# 3.0 Gray's Inn Road Facade

## Approved Planning Scheme

## S73 Proposal

2021 S73 Proposal | Gray's Inn Road Rear Elevation

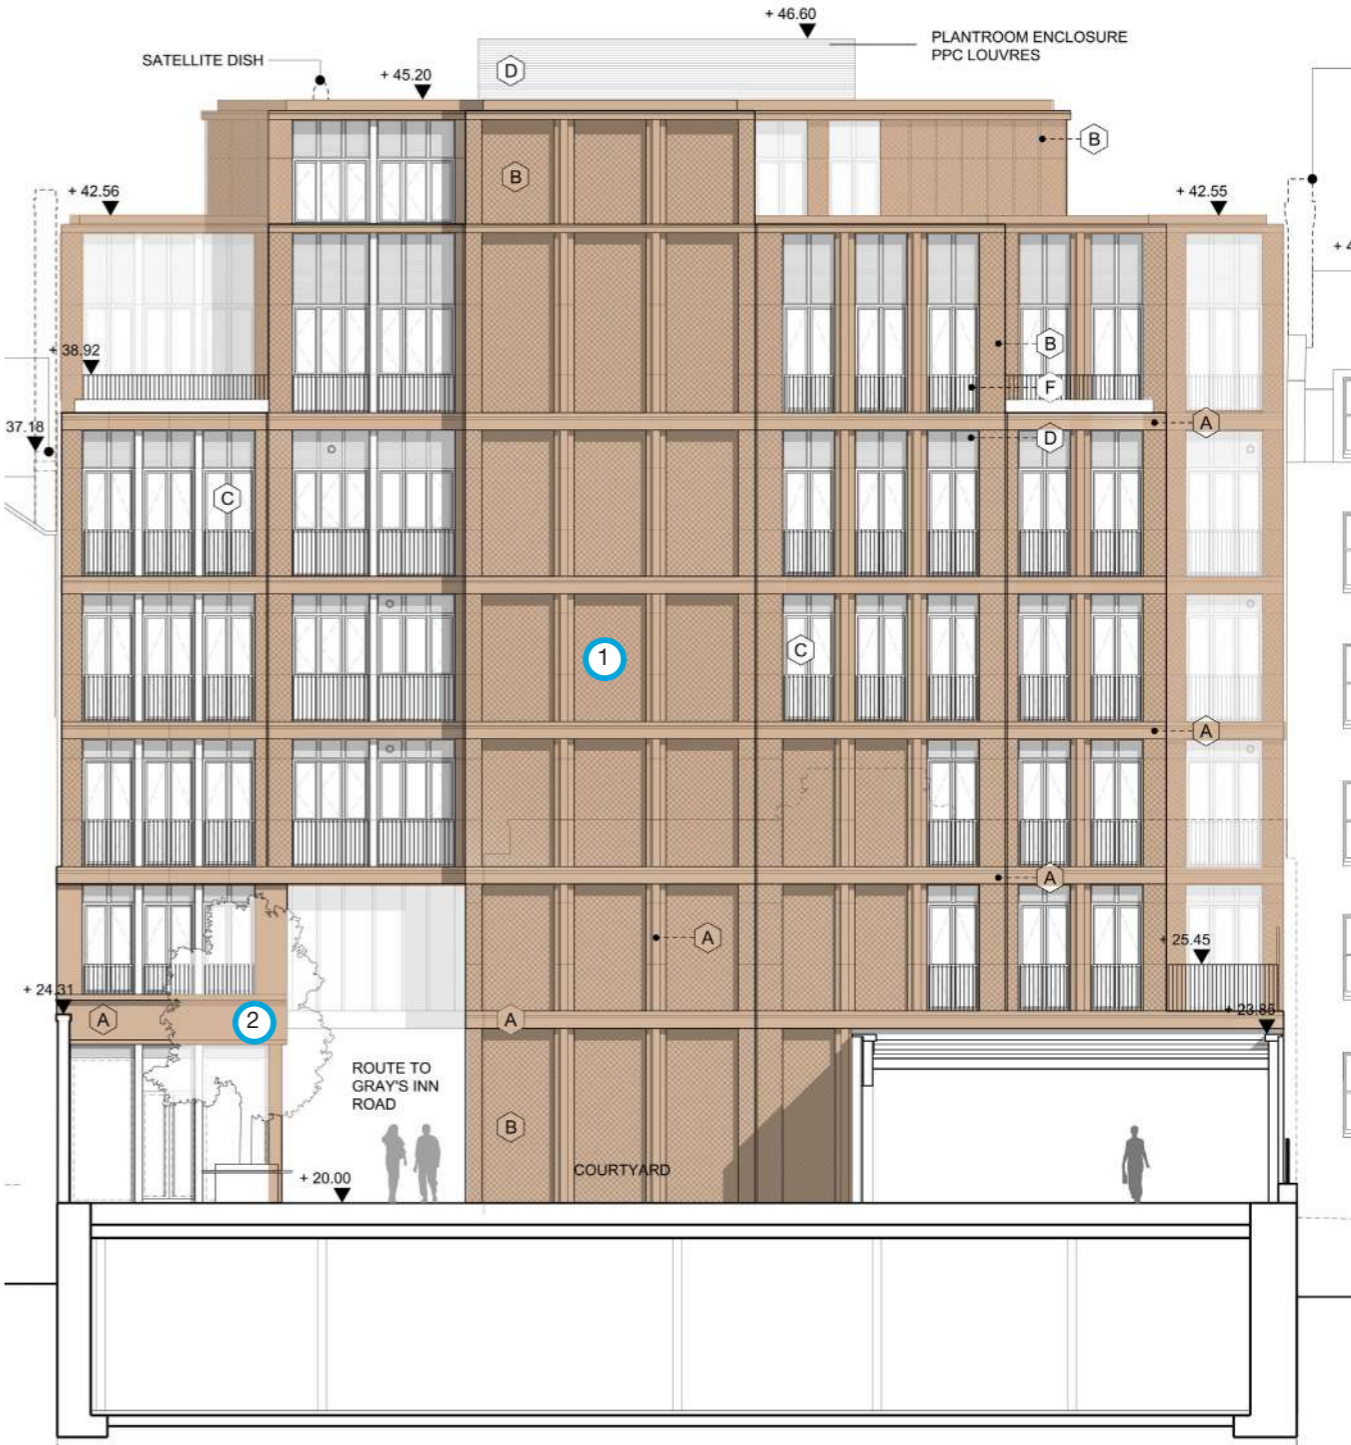
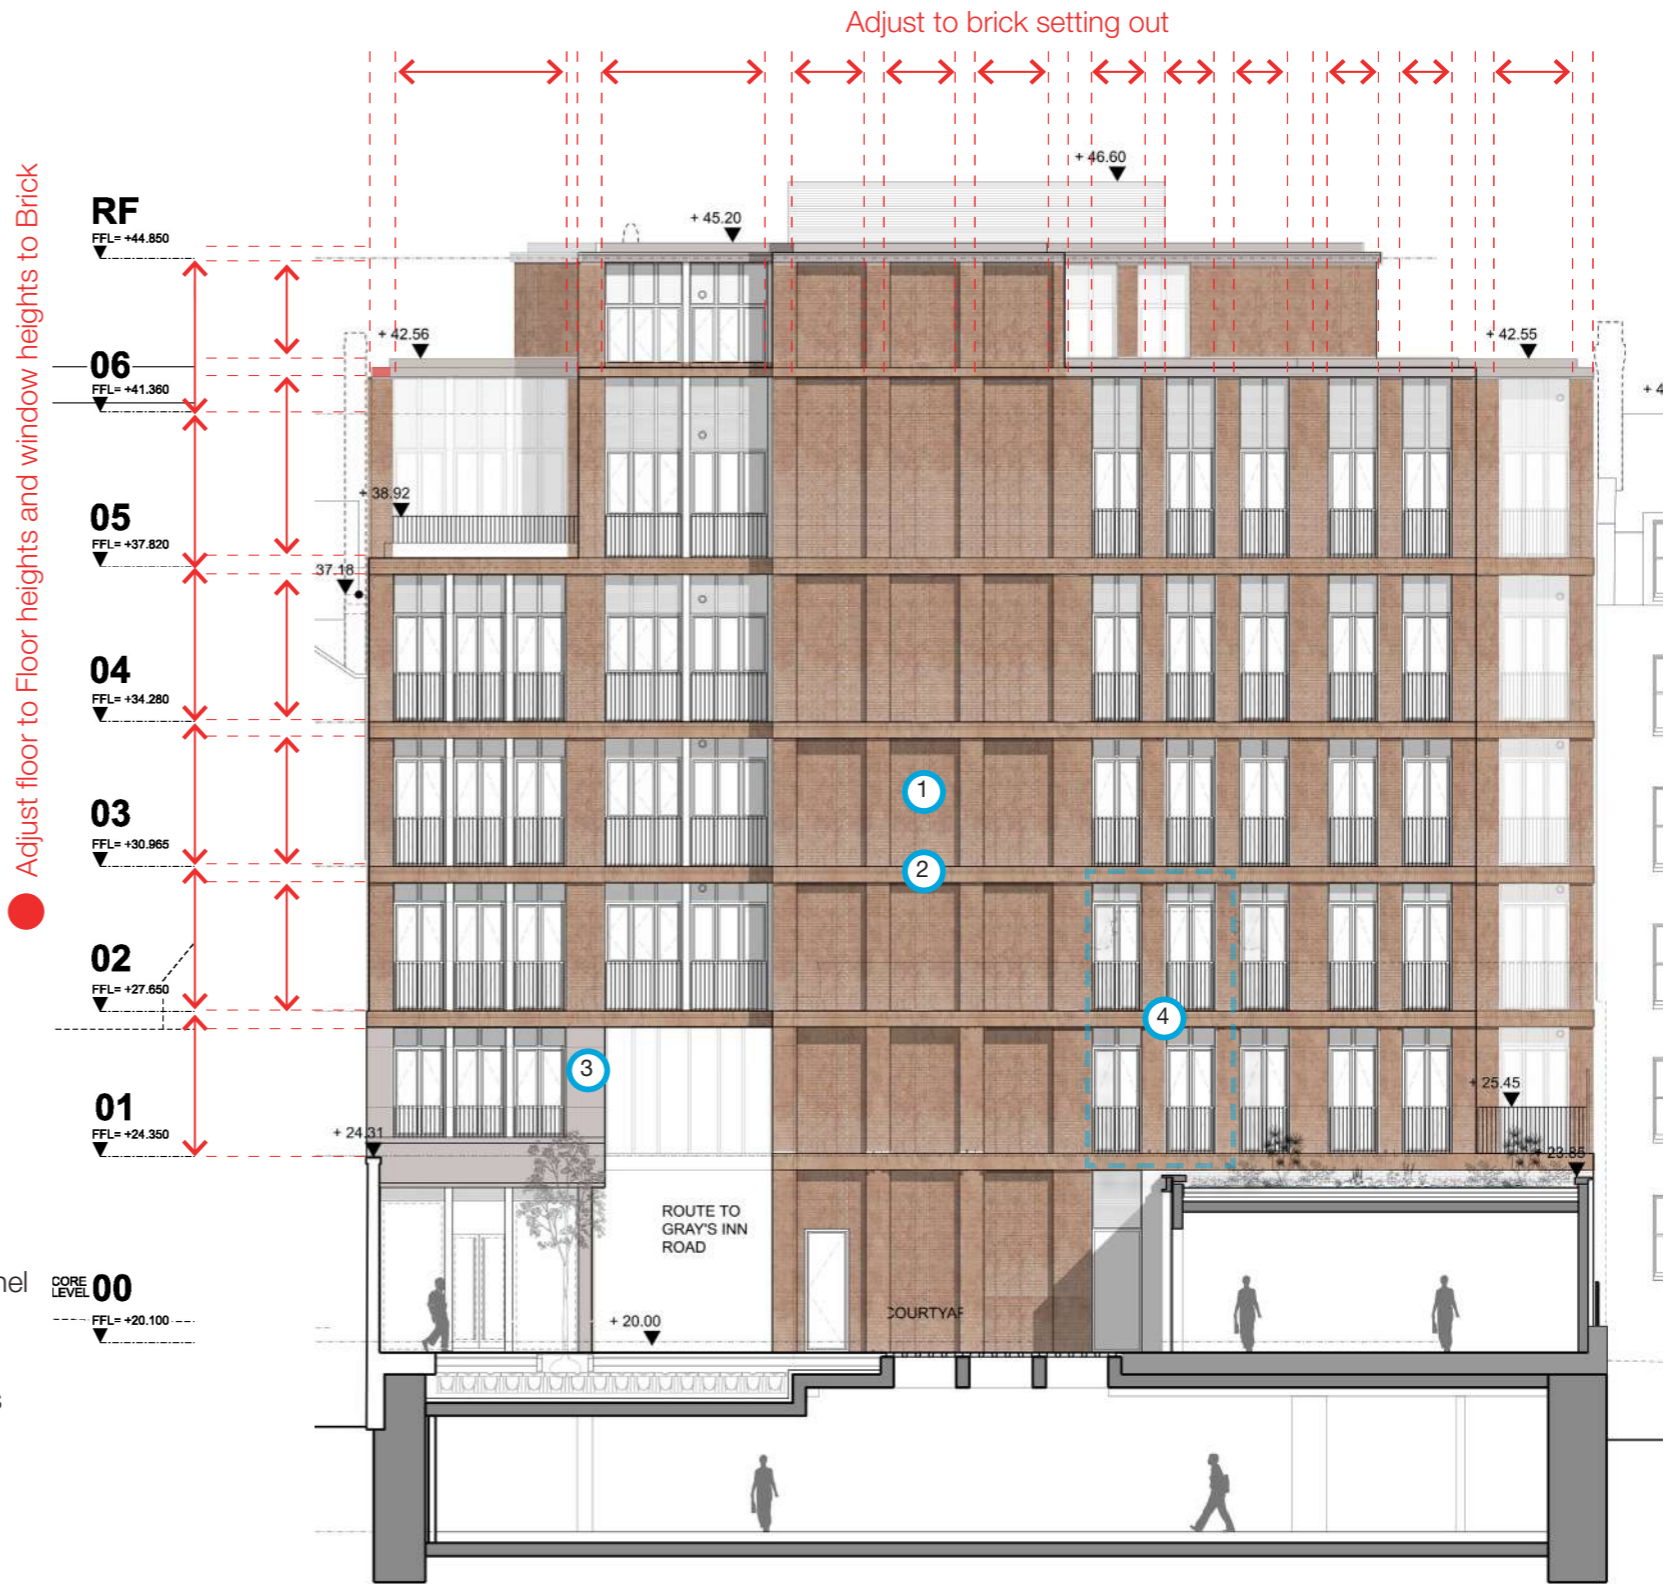
The updated s73 proposal for the Grays Inn Rd facade is to change the cladding on the rear to a hand laid brick from second floor upwards.

The proposal to revert to brick stems from reviewing the courtyard design; The Brain Yard building wall was approved as brick and the proposal here is to mirror that brick finish so that the courtyard is lined by a common material. A continuity of materiality in the courtyard enhances the tranquillity that is envisaged for the space.

As a consequence of reverting to hand laid brick on the rear facade, the Grays Inn Rd elevations require minor adjustments of datums to ensure alignment to brick dimensions.

Additional residential windows are proposed following the improvements made to the internal core design (see section 3.2). Two flats now have improved daylight provision as a result.

2021 S73 Proposal | 2nd Floor Plan

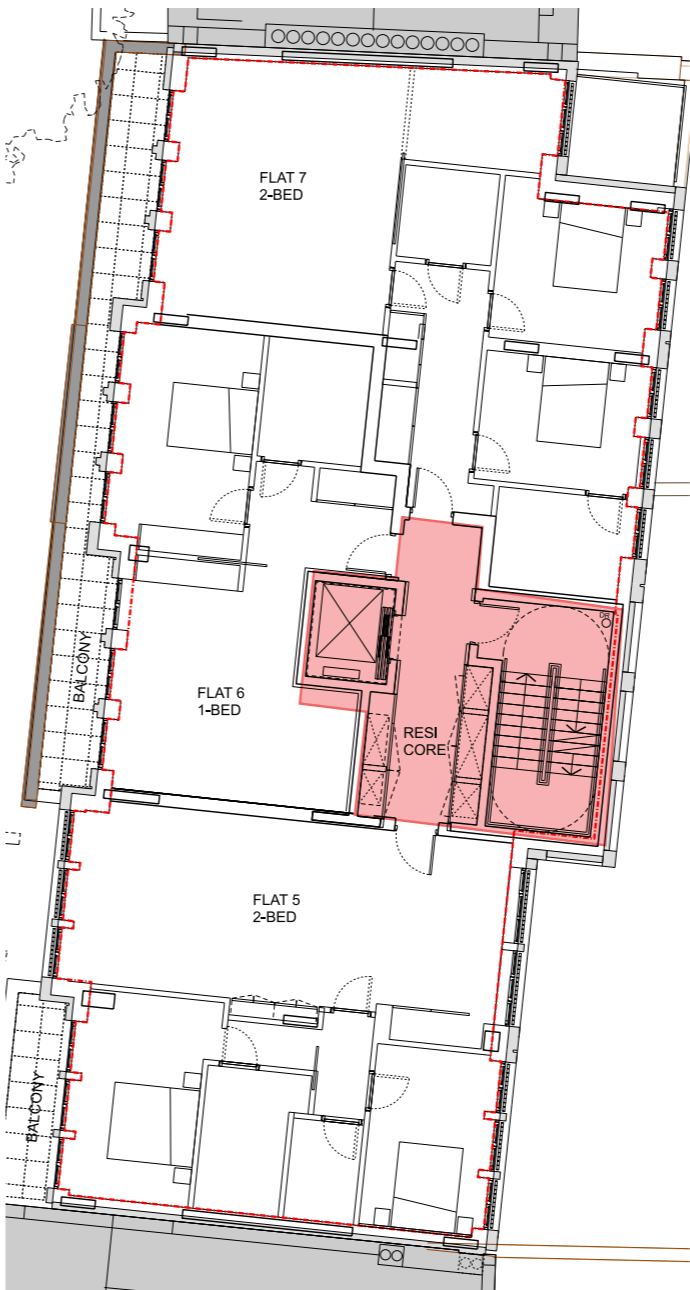
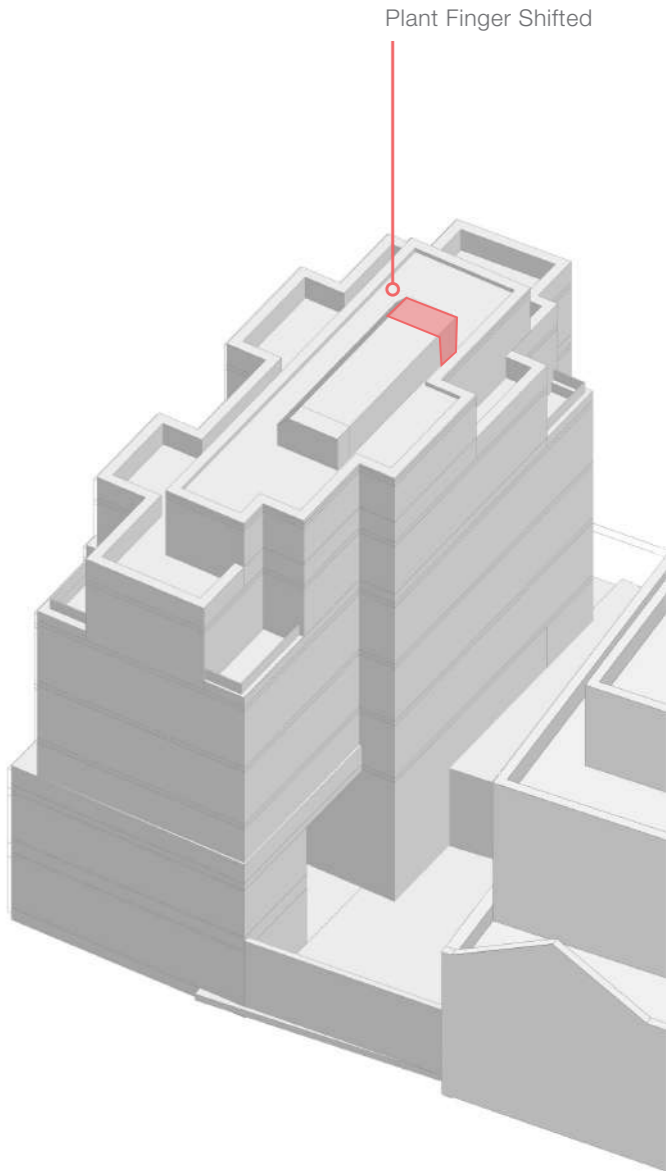
As part of the project design development, the residential core has been improved. The proposed core changes were initially to eliminate the transfer stair which resulted in an inefficiency in the residential floor layouts.

The new proposal for a continuous stacking stair unlocks an improved overall net to gross efficiency in the flat layouts. Additional improvements also result in the ground floor arrival experience and enhanced residential user facilities such as more storage, an improved post room and better connectivity with the public realm.

The roof plant has been adjusted slightly to ensure it encompasses the new efficient core layout. There is no impact on key views.

Internal flat layout adjustments are minor and the unit mixes are as per the 2017 approval.

2021 S73 Proposal | Roof Plan

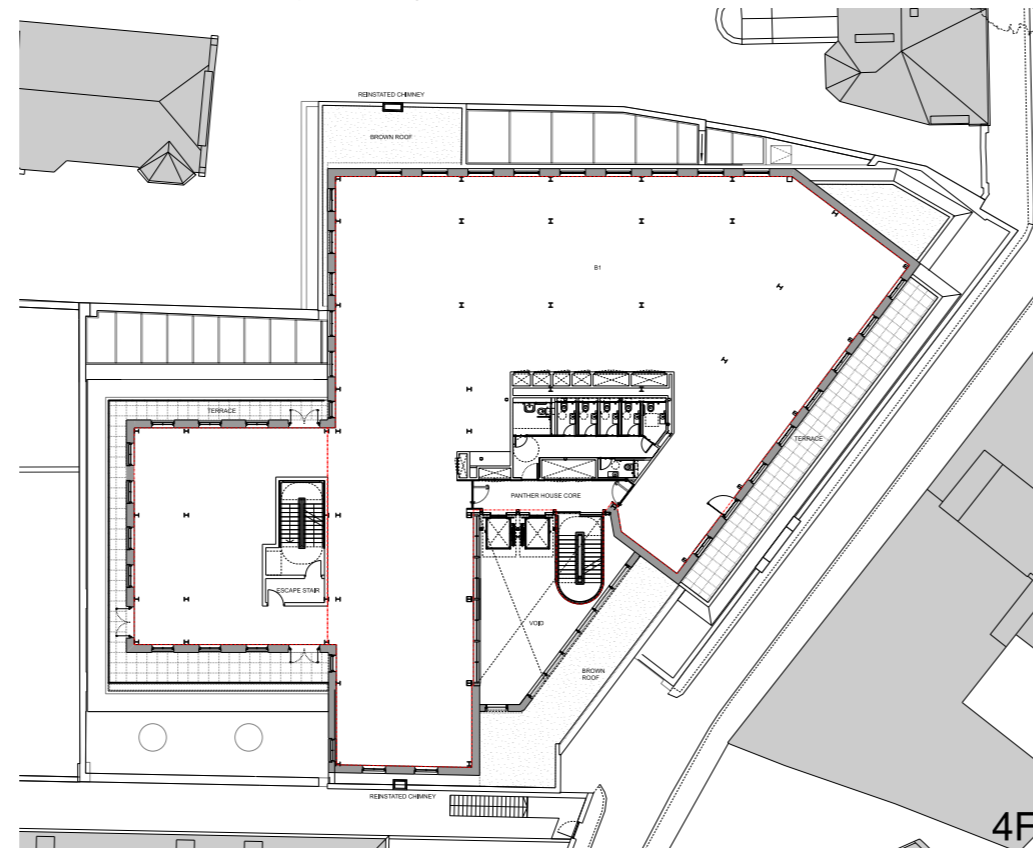
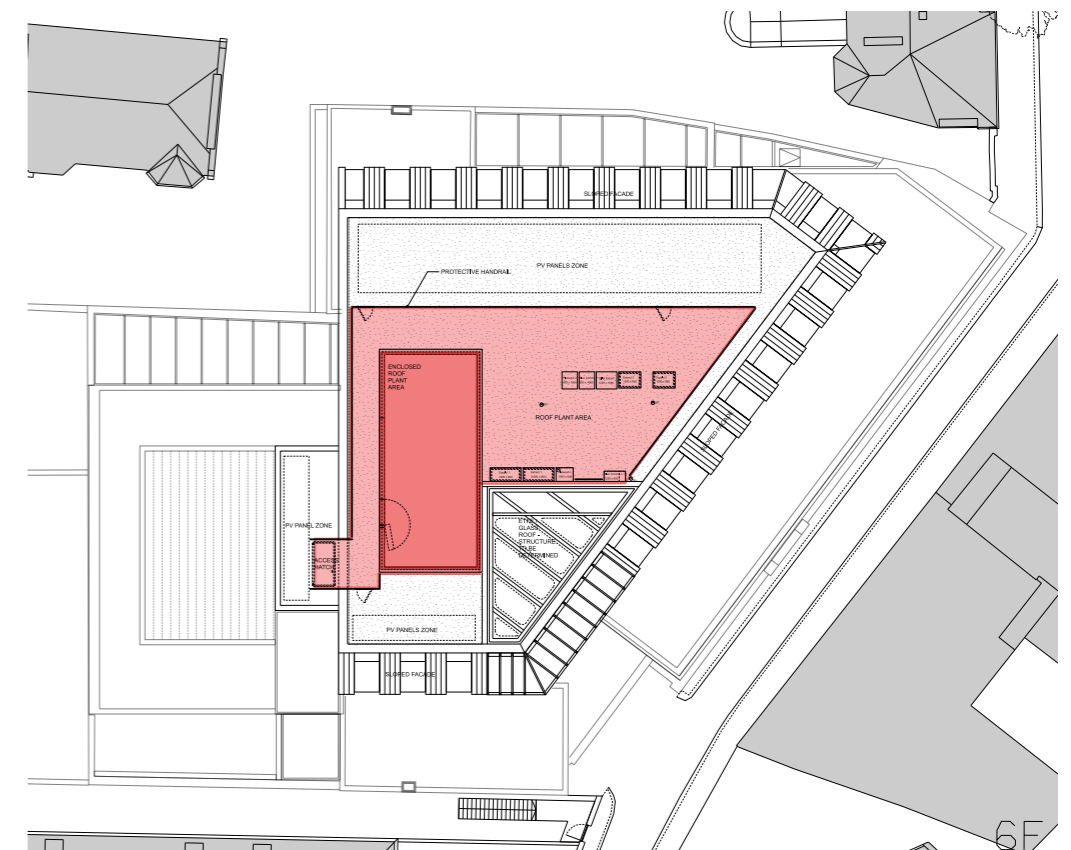
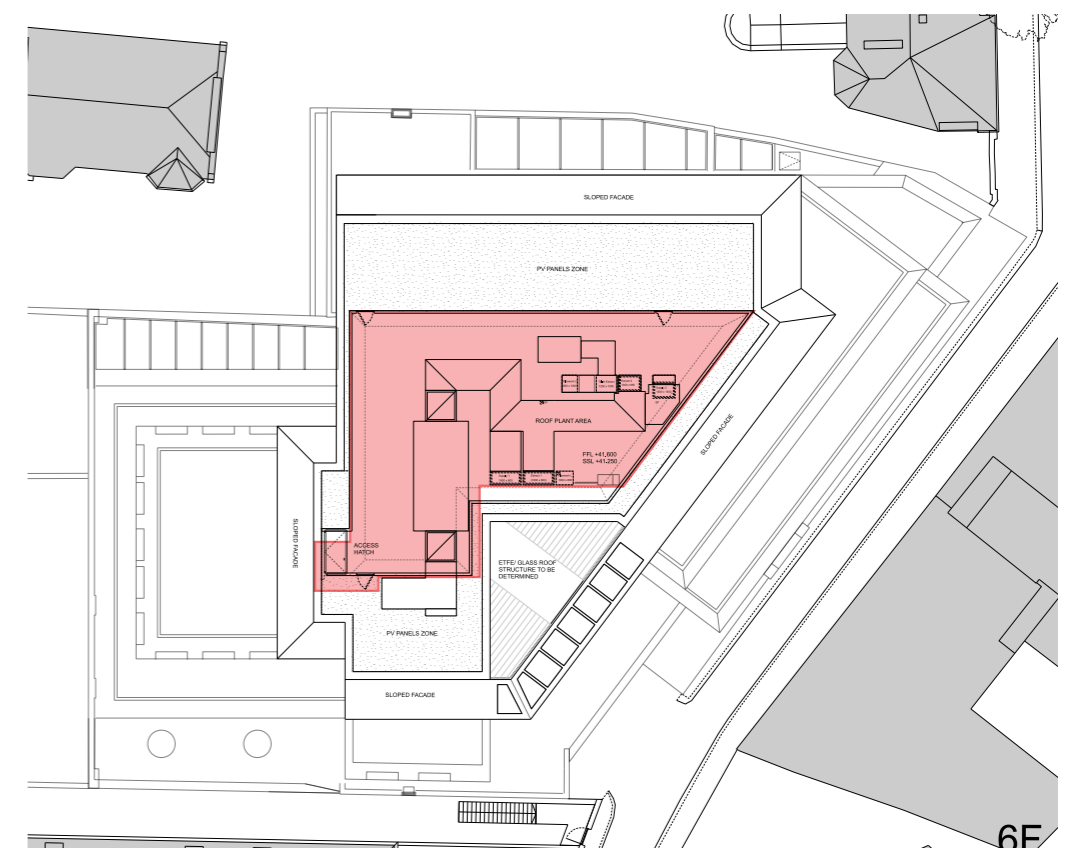
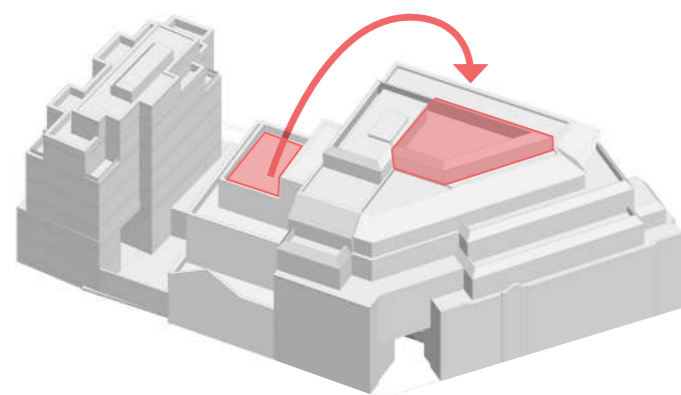
Within a very similar and improved massing of the consented 2017 scheme, plant can be consolidated and moved from Brain Yard roof to Panther House roof.

Moving plant from Brain Yard places it further away from neighbouring residential buildings reducing its visual and acoustic impact.

The relocation of plant also unlocks crucial staff amenity terrace space which was previously landlocked around a plant room in the consented scheme.
